Re: Certification Submittal for Final Building Certificate of Occupancy for
Yearout Mechanical, [C-17 / D1U10]
8501 Washington ST. NE
Architect's Stamp Dated 03/20/08

**Re: Traffic Certification for
Permanent Certification of Occupancy
Yearout Mechanical
8501 Washington NE
Albuquerque, NM**

Re: Yearout Mechanical, 8501 Washington Street, Traffic Circulation Layout
Architect's Stamp dated 11-07-07 (C17-D001U10)

PROJECT
Yearout Mechanical, Inc.
Warehouse
8501 Washington St. N.E.

1 SITE PLAN

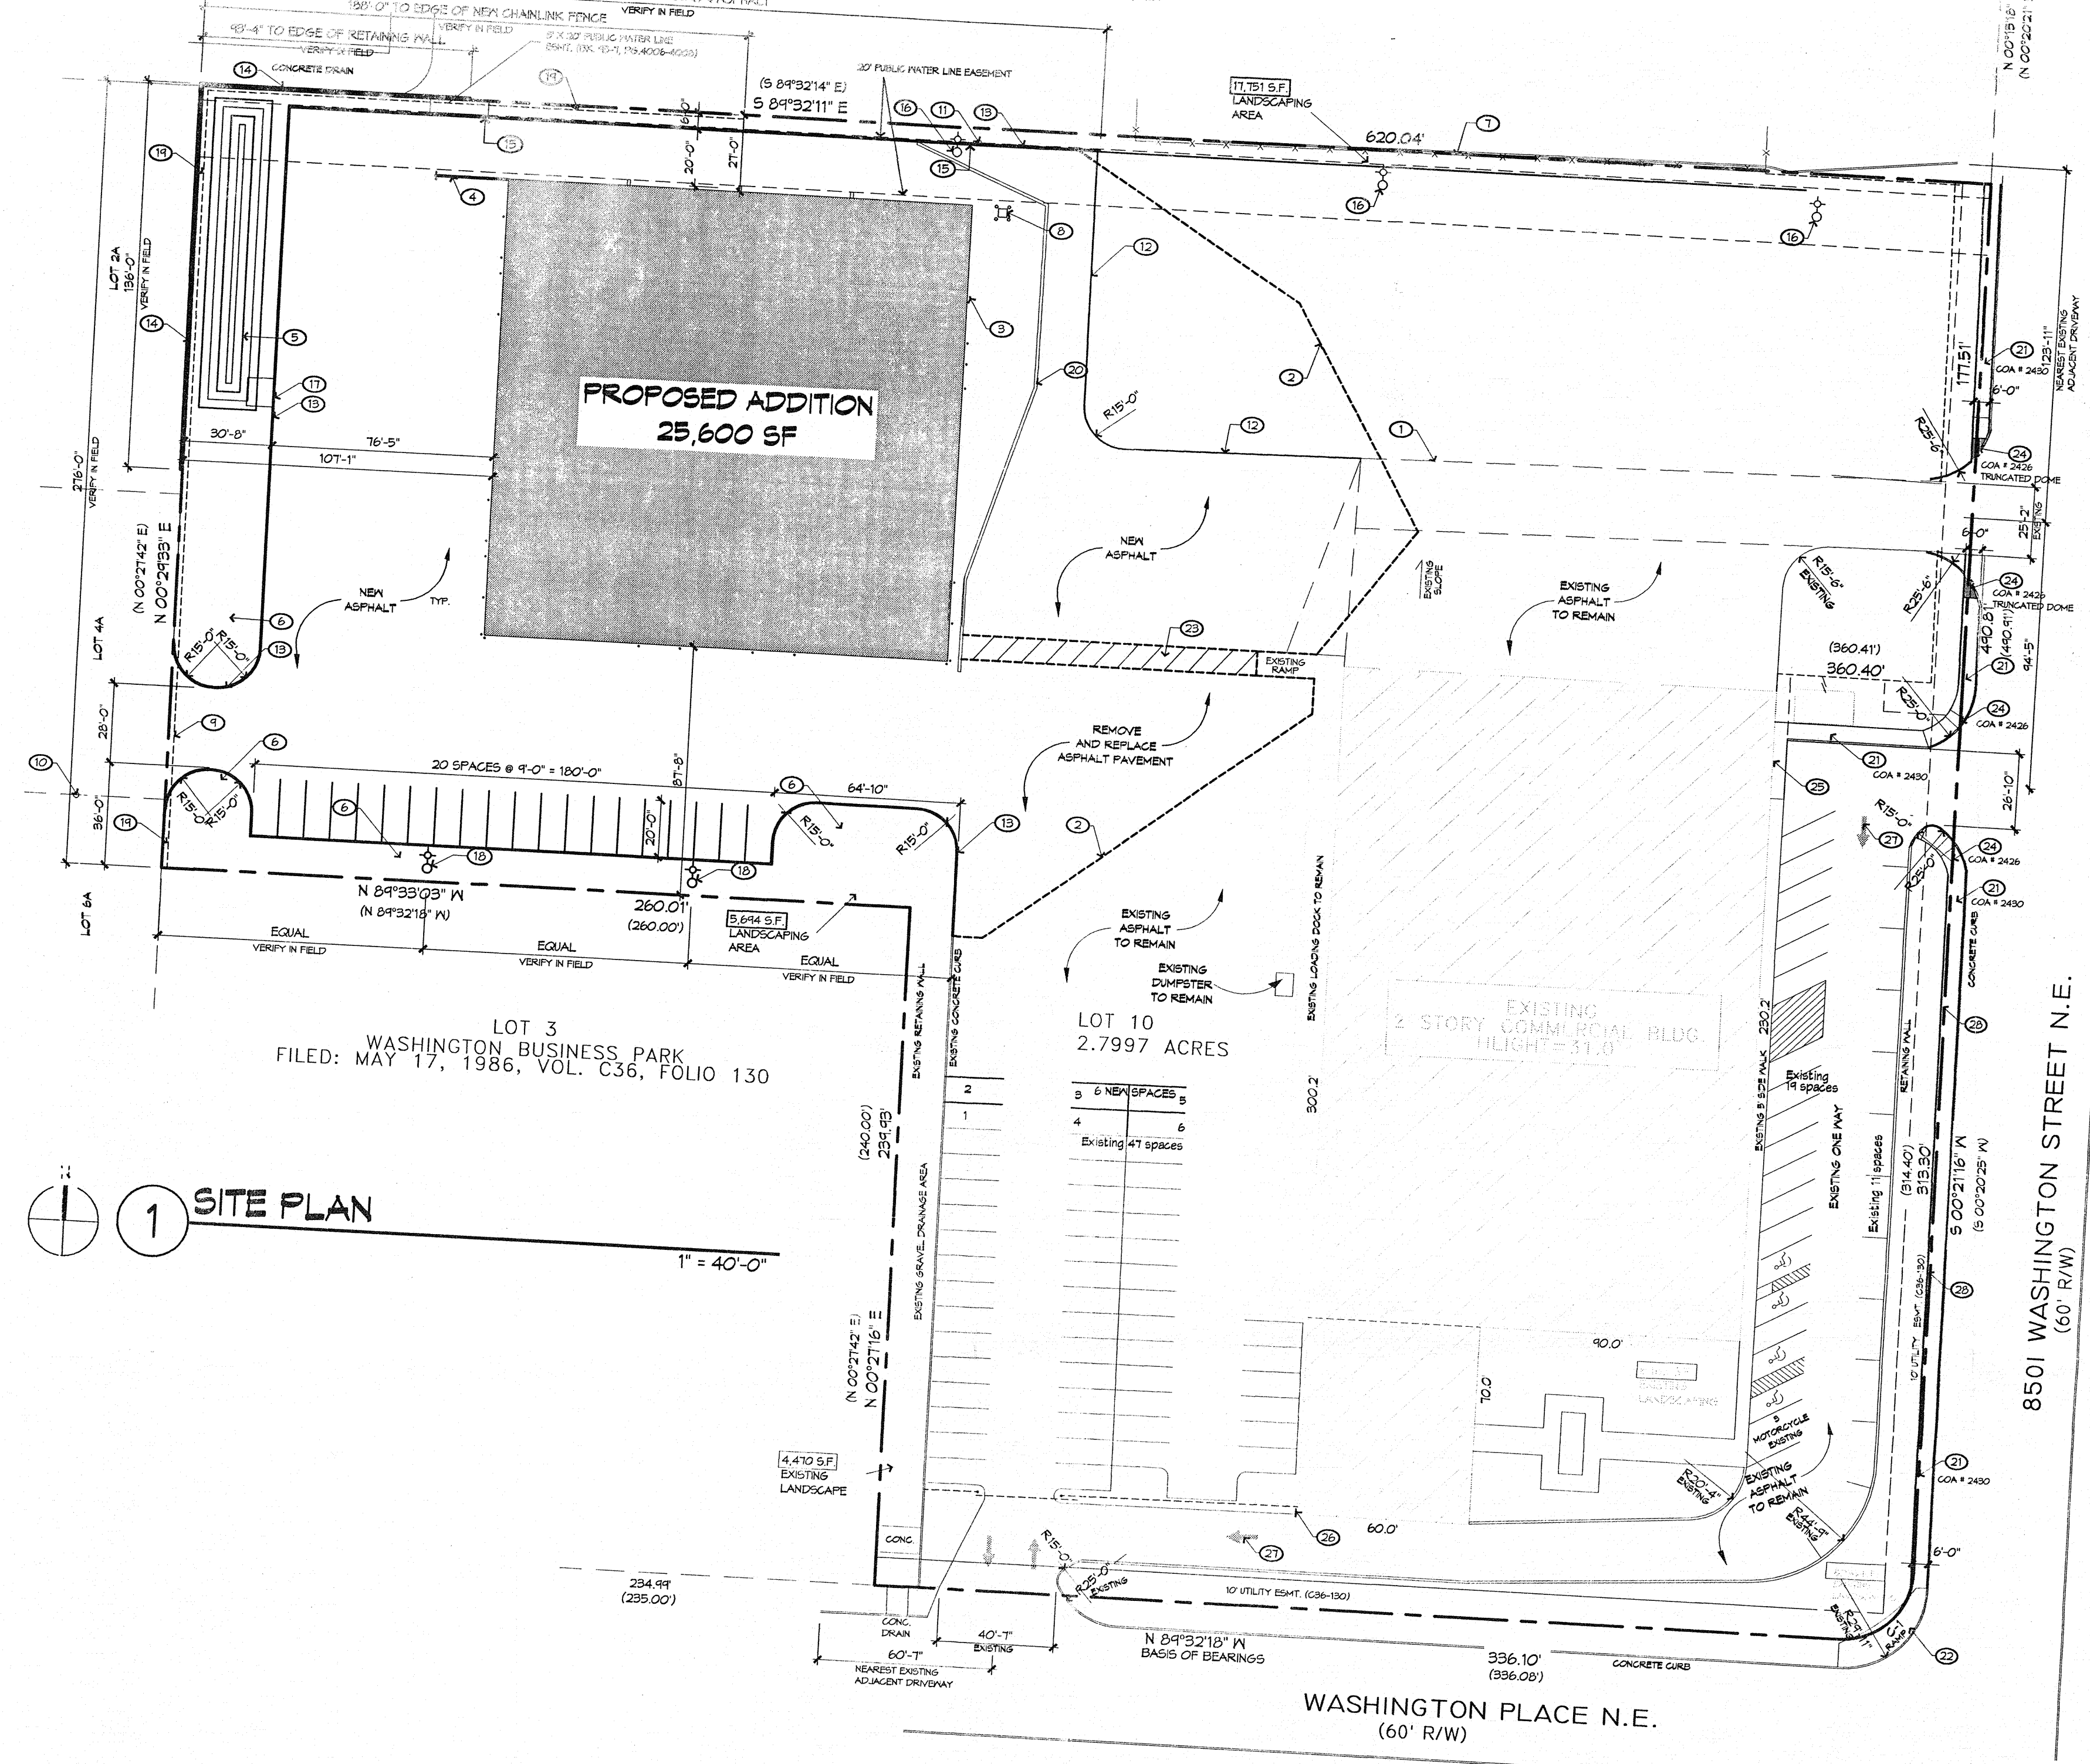
Comment #4 asks for a side walk easement to be shown. This will be shown on our updated re-plat for approval. - *Not on plat - will need paper easement*

Comment #6 asks for the operation of the gate. I was informed that the gate is always left closed. However, during business hours the gate is operated by a sensor for opening and exiting the site as needed. After business hours the gate is operated by a key card for opening and sensor for existing.
